**SUNDRY NOTICES AND REPORTS ON WELLS**

2. NAME OF OPERATOR  
Continental Oil Company

5. LEASE C-7979	
6. IF INDIAN, ALLOTTEE OR TRIBE NAME	
7. UNIT AGREEMENT NAME	
8. FARM OR LEASE NAME Conoco Federal 22	
9. WELL NO. 2	
10. FIELD OR WILDCAT NAME Pierre "B"	
11. SEC., T., R., M., OR BLK. AND SURVEY OR AREA Sec. 22, T9N, R78W	
12. COUNTY OR PARISH Jackson	13. STATE Colorado
14. API NO.	
15. ELEVATIONS (SHOW DF, KDB, AND WD) 8345' GI

Well location, SOUTH MCCALLUM [redacted] No 22-2, located as shown in the NW 1/4 SW 1/4 Section 22, T 9 S, R 78 W, 6th P.M. Jackson County, Colorado.

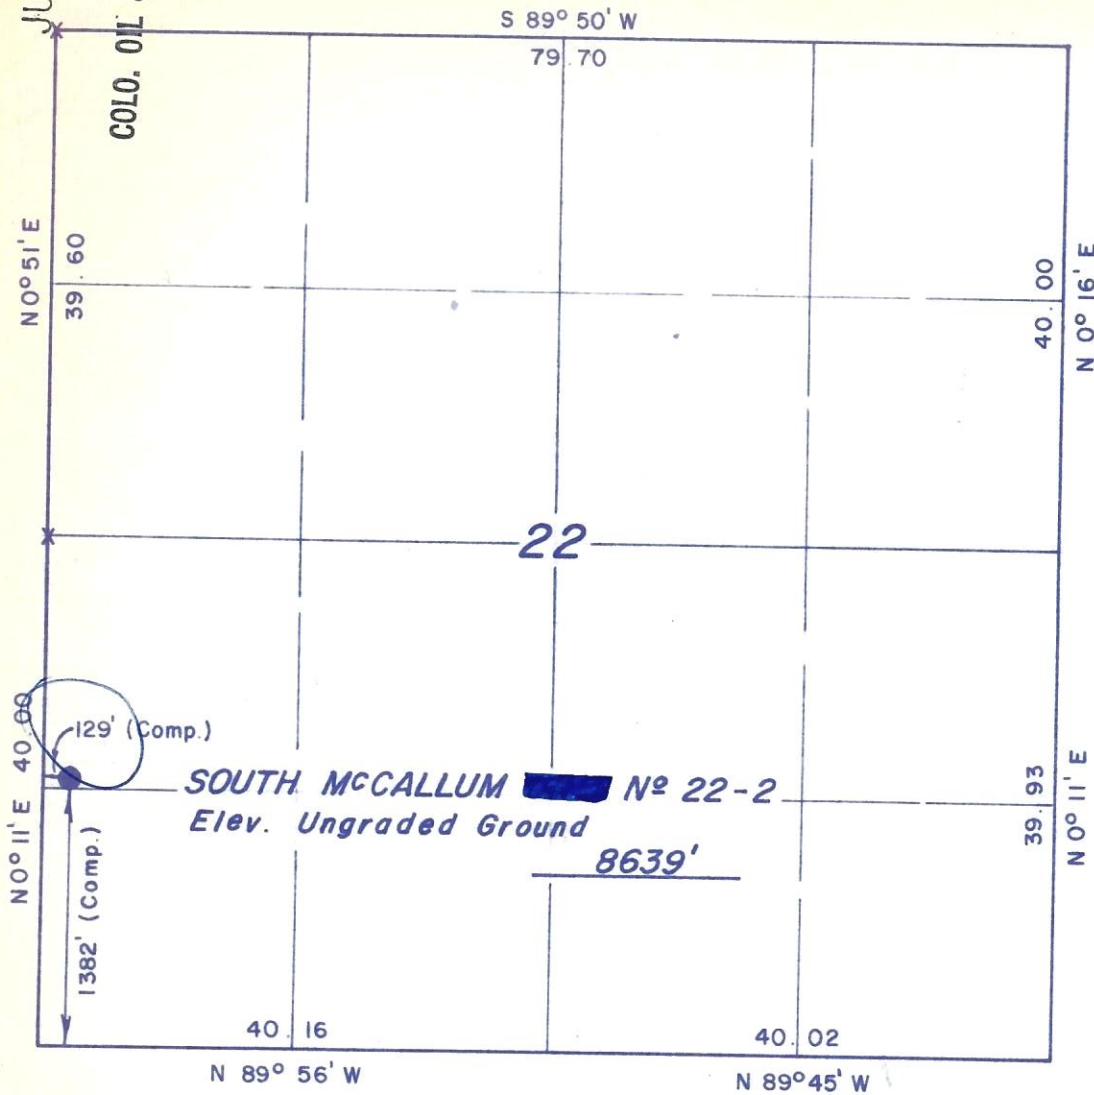
When the Application to Drill this well was submitted, the elevation was incorrectly stated because of a surveying error. The elevation shown on the attached plat is the corrected one. This plat is showing the old location which was changed to the location shown above.
